Product Change Notification

Date Issued :	July 30, 2024	PCN Number :	515614
Reason for Change :	Packaging Method/Quantity Changing		
Description of Change :	This notification is to inform you about parts listed will undergo changes for packaging size change. No changes will be made to product as part of this change.		
Reason for Short Notice :	Corrective Actions		
Assessment of Change :	First Article Inspection		
Planned Implementation Date :	October 31, 2024		
Customer Sample Availability Date:	August 16, 2024		
Last date to request Samples by Customer : August 30, 2024			
Please note if Samples are not requested as per Customer Samples Request date, it may take additional 4-6 weeks to arrange Samples.

Before Picture

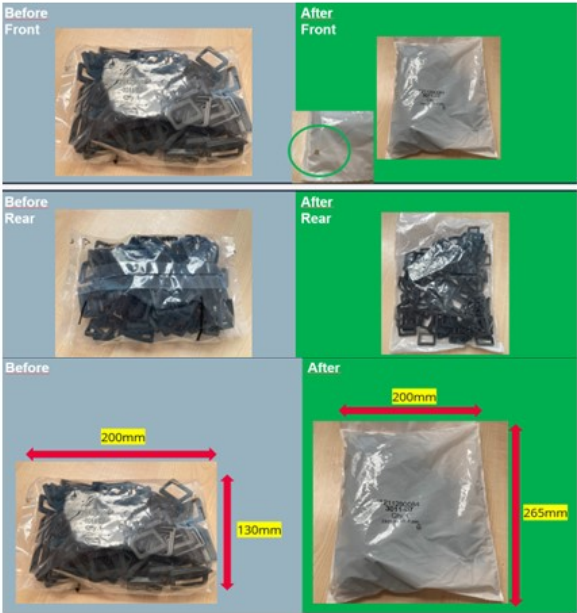
- Due to the inability to continue working with the currently used machine and the lack of service support and spare parts, we are withdrawing the current packaging machine from the production line. The packaging process on the new device will be similar, with the following changes:

New Bag: One surface of the bag will be milky white, and the dimensions of the bag will be different.

- Product Impact
 - Fit, Form, or Function: There will be no impact on the fit, form, or function of the products.
 - New Bag: The bag will be changed from the current polyethylene film to a new plastic bag
- Part Number Impact
 - Impacted Parts List: Please refer to the attached document for the list of impacted part numbers.
